# CHAPTER 6 – TYPE IV MATERIALS

**Change:** Member dimension table (Chapter 23-2304.11)

### **Type IV A    -----    Type IV B    -----    Type IV C**

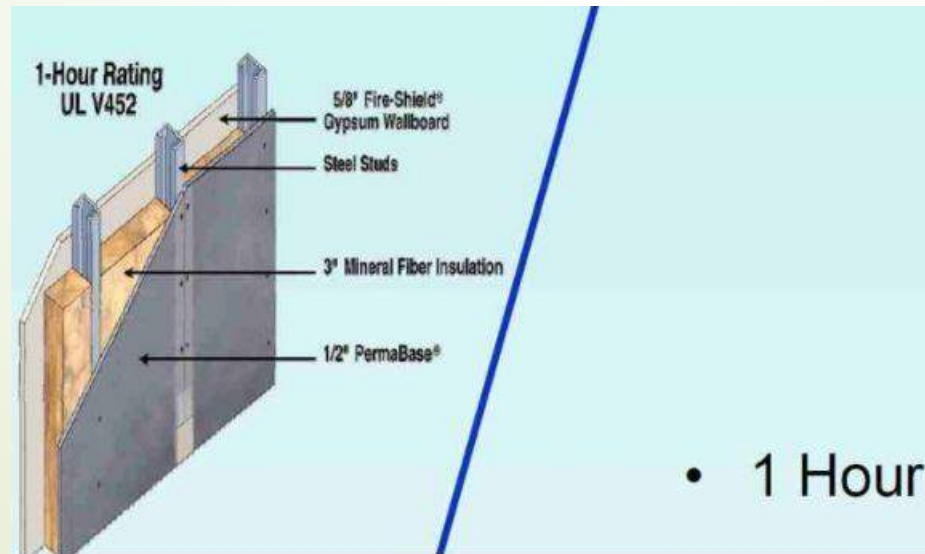
Three new types of construction are introduced under this method, all three of  
Which are organized under Type IV construction. The new types of construction:

**Type IV A:** Buildings with an automatic sprinkler system require 3-hour fire-resistance-rated Primary structural frame elements and bearing walls, with 2-hour fire-resistance-rated floors.  
[Exposed timber surfaces must be entirely encapsulated.](#)

**Type IV B:** Buildings with an automatic sprinkler system require 2-hour fire-resistance-rated Primary structural frame elements and bearing walls, with 2-hour fire-resistance-rated floors.  
[A calculated percentage of the exposed timber surfaces may remain exposed under this type.](#)

**Type IV C:** Buildings with an automatic sprinkler system require 2-hour fire-resistance-rated Primary structural frame elements and bearing walls, with 2-hour fire-resistance-rated floors.  
[Exposed timber surfaces are permitted to remain entirely exposed under this type.](#)

**706.2 Structural Stability.** Fire walls shall be designed and constructed to allow collapse of the structure on either side without collapse of the wall under fire conditions. Fire walls designed and constructed in accordance with NFPA 221 shall be deemed to comply with this section.

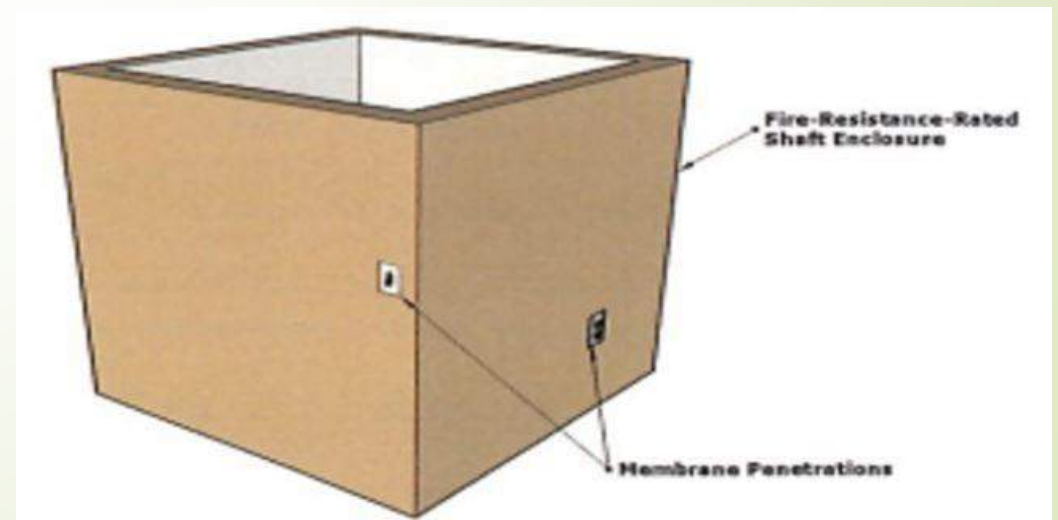
**Change:** The change allows the floor or roof sheathing to go through the light frame double walls.

**Exception:** In Seismic Design Categories D through F, where double fire walls are used in accordance with NFPA 221, floor and roof sheathing not exceeding  $\frac{3}{4}$  inch (19.05 mm) thickness shall be permitted to be continuous through the wall assemblies of light frame construction.

## CHAPTER 9 – 903.2.1 GROUP A FIRE SPRINKLERS

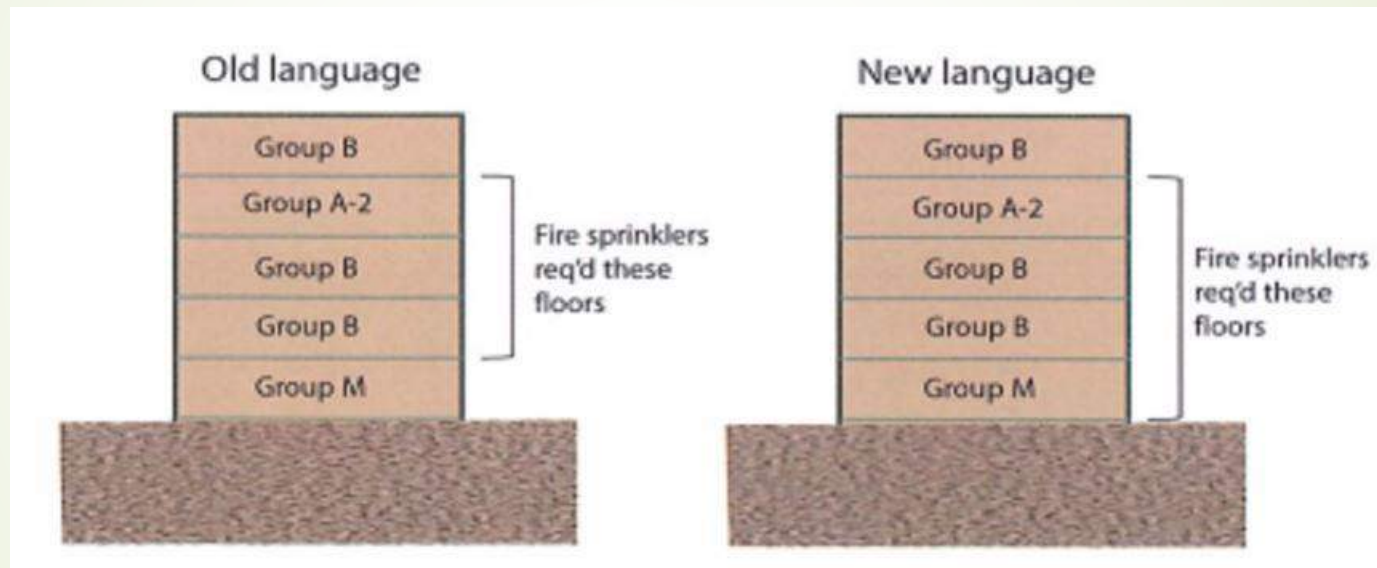
**Change:** There was language added to clarify fire sprinkler requirements for Group A occupancies.

- Notes:**
- The 2015 code language used the term intervening which ended up excluding the floor at the level of exit discharge.
  - The new language reads “including the level of exit discharge”

**Item 3 options include the following:**

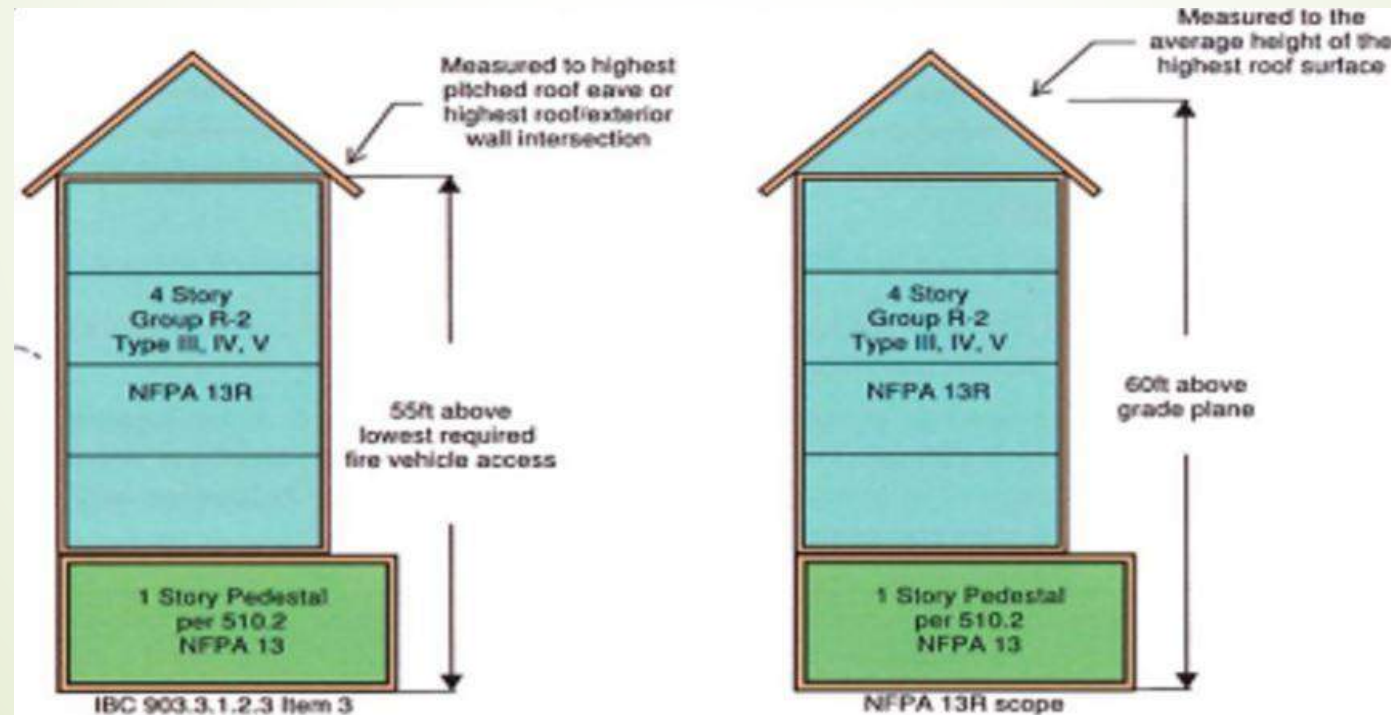
1. Mirrors the NFPA 13R requiring sprinklers in attics w/living or storage space
2. Mirrors NFPA 13R requiring one head over fuel-fired equipment
3. This change is new:
  - Applies to Type III, IV or V
  - Roof assembly greater than 55 feet above lowest level of required FDVA
  - Not otherwise required by item 1.

- **Fire sprinklers**
- **Noncombustible attic construction**
- **Fire-retardant-treated wood construction**
- **Fill attic with noncombustible insulation**

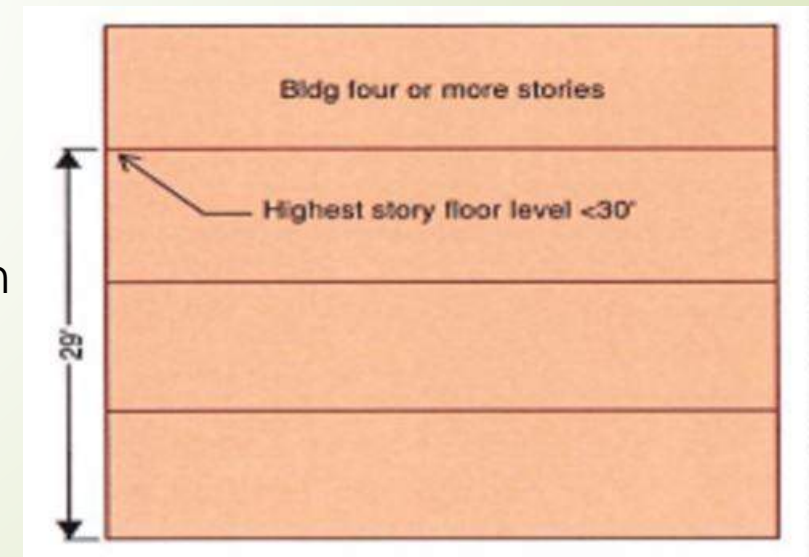
**Change:** Class III standpipes are required in buildings of four or more stories.

Standpipe systems required due to Number of stories even though Highest floor level is less than 30 feet

NEW

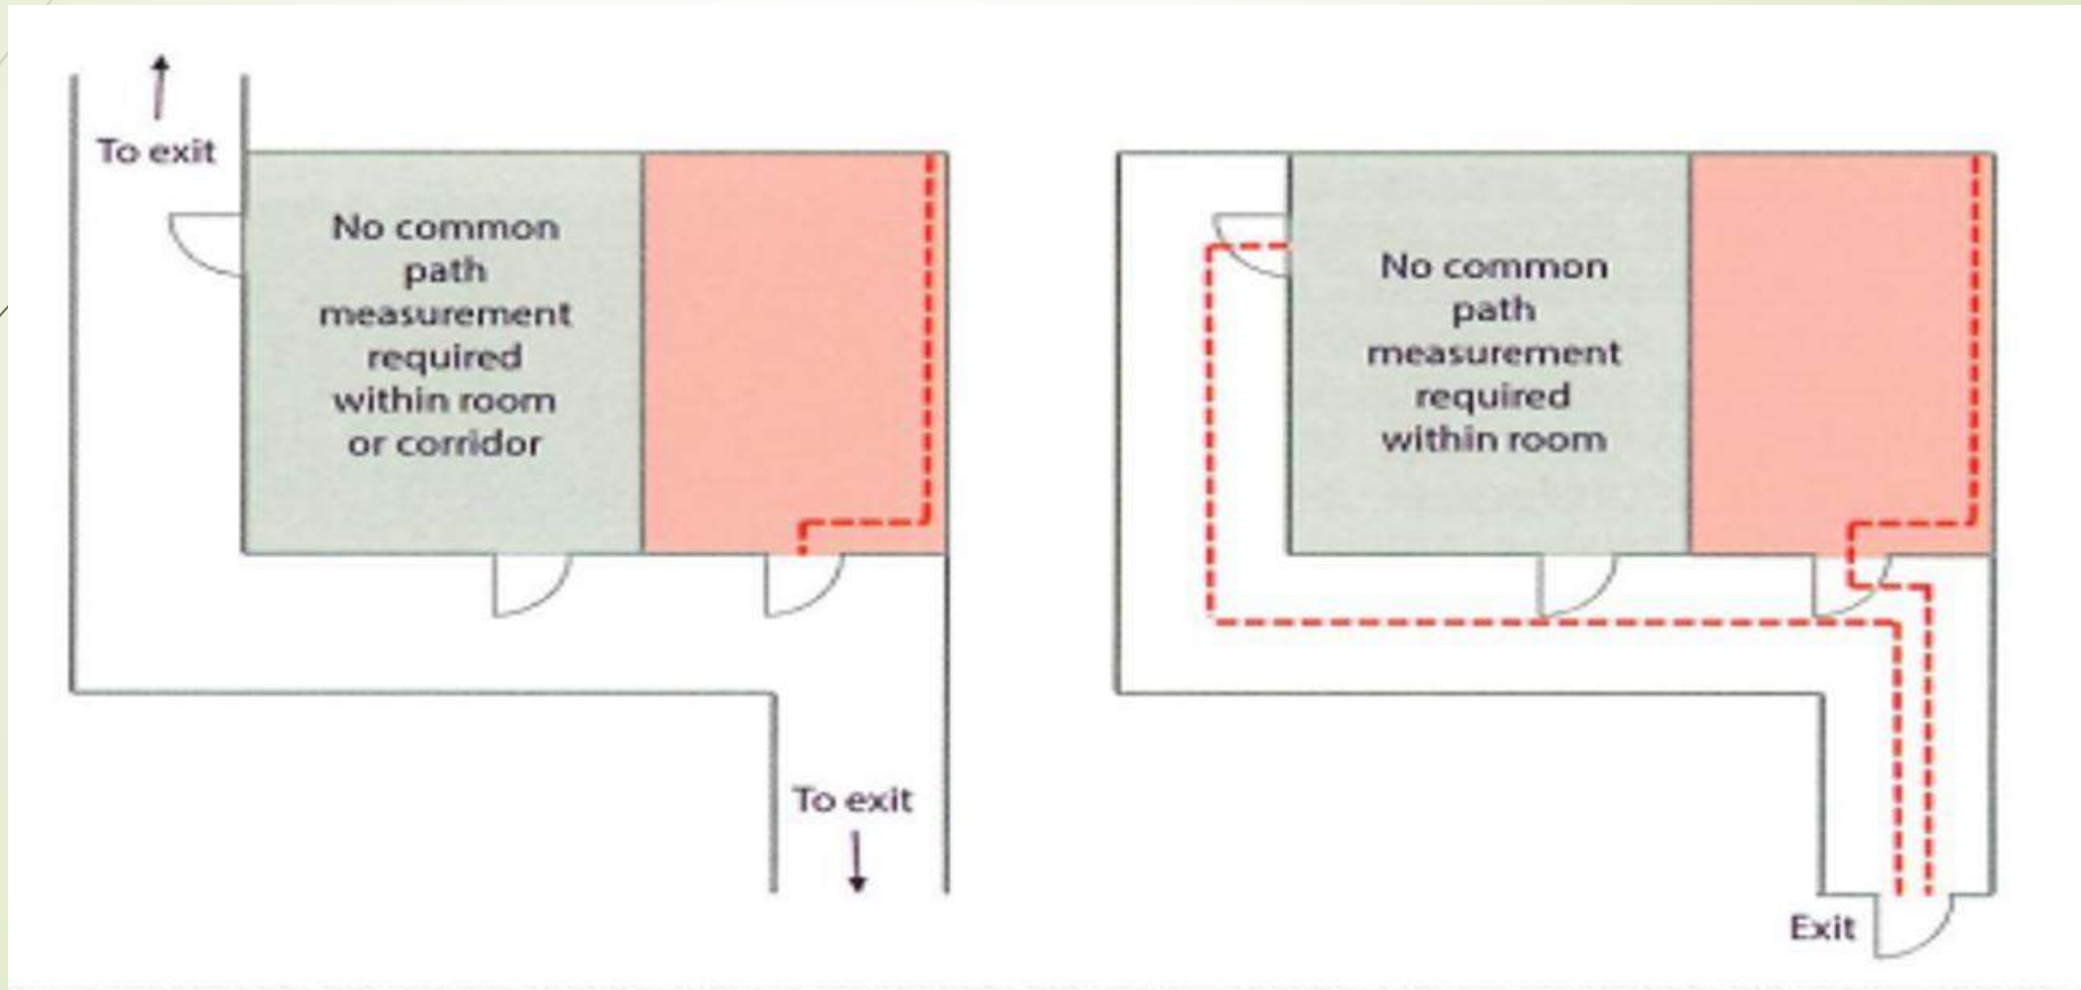
**Change:** Common path of egress travel definition has been revised.

**COMMON PATH OF EGRESS TRAVEL.** That portion of exit access travel Distance measured from the most remote point of each room, area or space to That point where the occupants have separate and distinct access to two exits or Exit access doorways,

- Makes more clarification that measurement is taken from each space independently.
- Clarifies that access is to two exits or exit access doors.
- Language has been revised to more closely align with the definition for Exit Access Travel Distance.

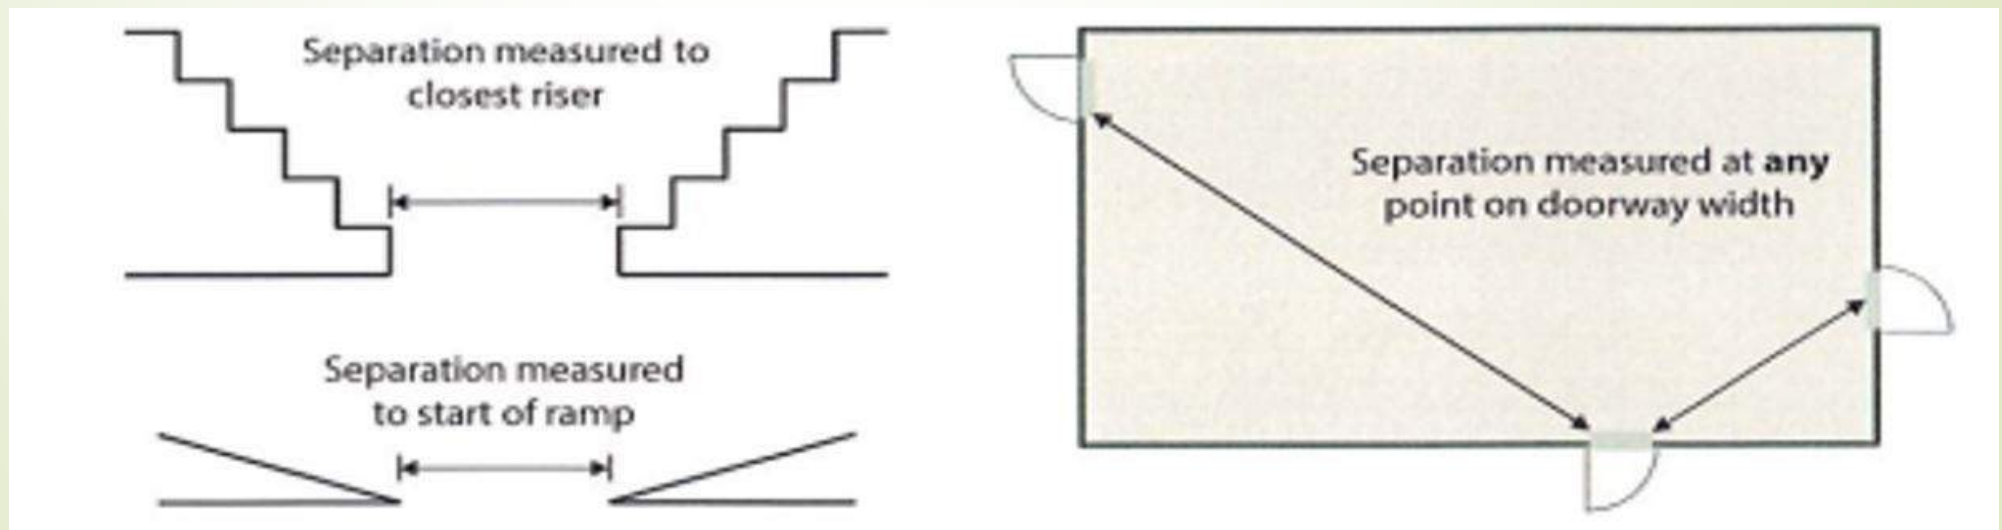
**Change:** Change was made for exit and exit access calculations for occupant loads from adjacent stories.

### **1007.1.2 Three or more exits or exit access doorways.**

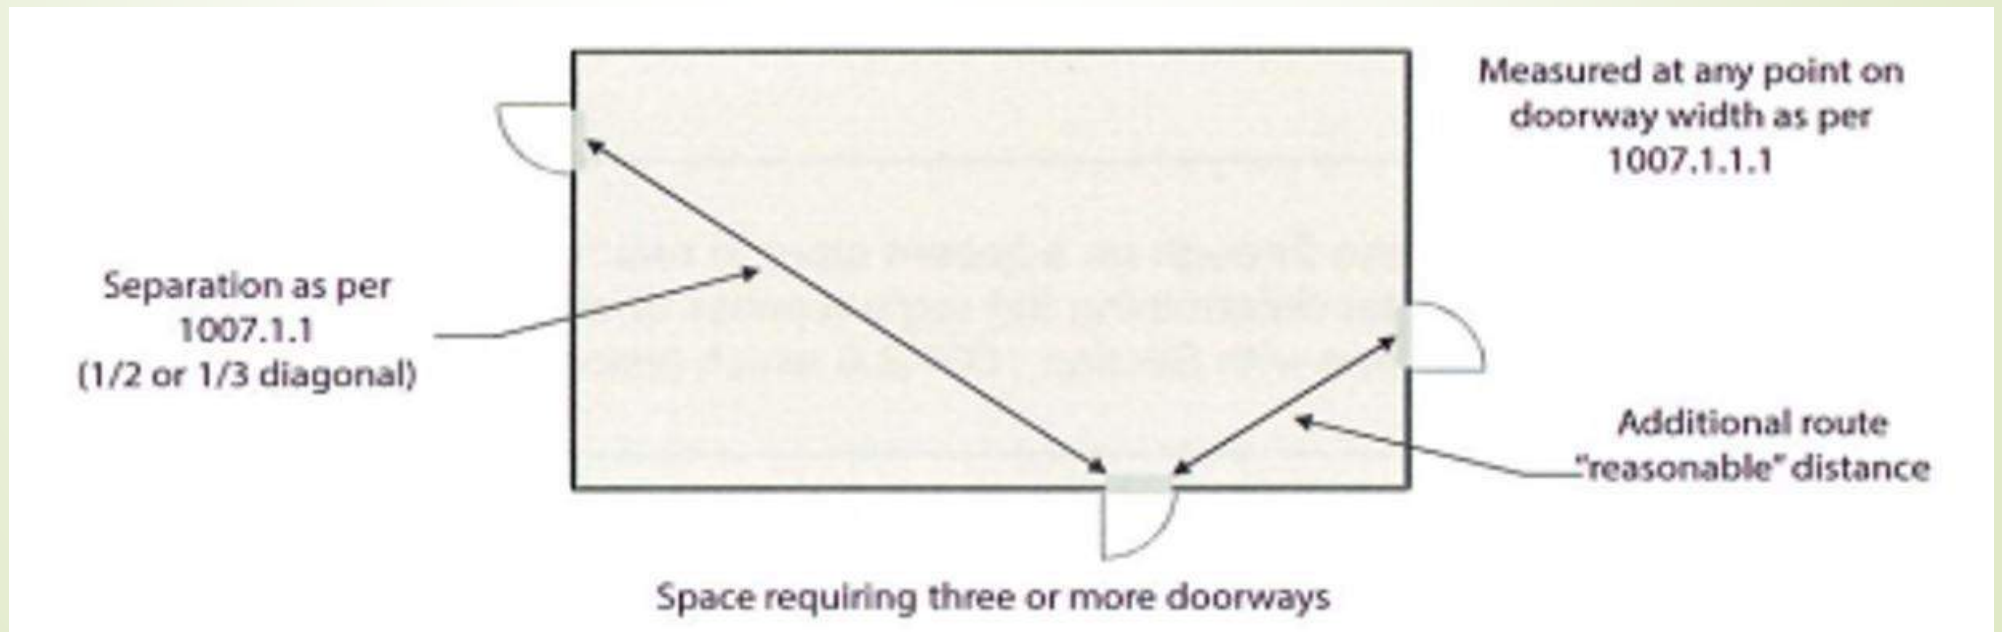
**Change:** There was an addition to the code to clarify exit configuration for three or more exits or exit access doorways.

Where access to three or more exits is required, not less than two exit or exit access doorways shall be arranged in accordance with the provisions of Section 1007.1.1.

Additional required exit or exit access doorways shall be arranged a reasonable distance apart so that if one becomes blocked, the others will be available.

**1008.2.3 Exit discharge.** Illumination shall be provided along the path of travel for the *exit discharge* from each exit to the *public way*.

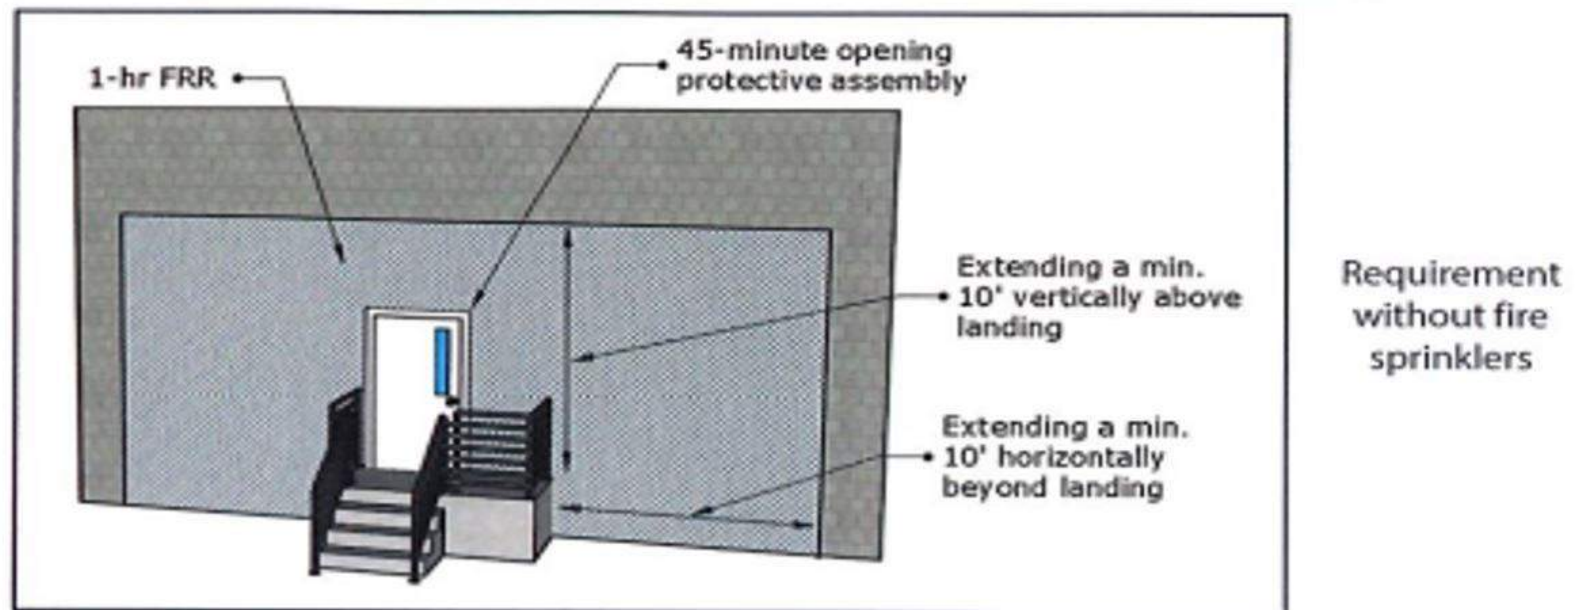
**Change:** Exit discharge illumination.

**Exception:** Illumination shall not be required where the path of the *exit discharge* meets both of the following requirements:

1. The path of exit discharge is illuminated from the exit to a safe dispersal area complying with Section 1028.5.
2. A dispersal area shall be illuminated to a level not less than 1 footcandle (11 lux) at the walking surface
